SERVICE BULLETIN	
Product:	French Door Refrigerators
Bulletin Date:	03/19/2015
Bulletin Number	ASC20150319001
Models:	RF23HCEDB/ RF23HCEDT/ RF23HSES/ RF23HTEDB / RF24FSEDB/ RF28HDEDB/ RF28HDEDT/ RF28HFEDB/ RF28HFEDT/ RF28HMEDB/ RF28HMELB/ RF30HBED/ RF30HDEDT/ RF31FMEDB / RF31FMESB/ RF323TEDB / All Colors

SUBJECT: Door Alignment Screw Change

Allen tool no longer supplied.

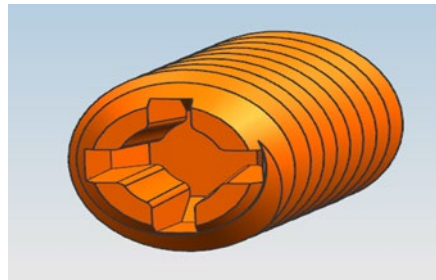
- The Allen bolt located in the right middle hinge is being replaced by a Phillips head bolt.
- All new units, beginning with March 2015 production, will have the Phillips head bolt.
- All right door adjustments can now be made using a Phillips head screwdriver.
- The Allen tool will no longer be supplied with the unit.
- The user manual will be updated to reflect the change.

Old Allen Bolt - 6011-001442

New Phillips Head Bolt - DA66-00688A
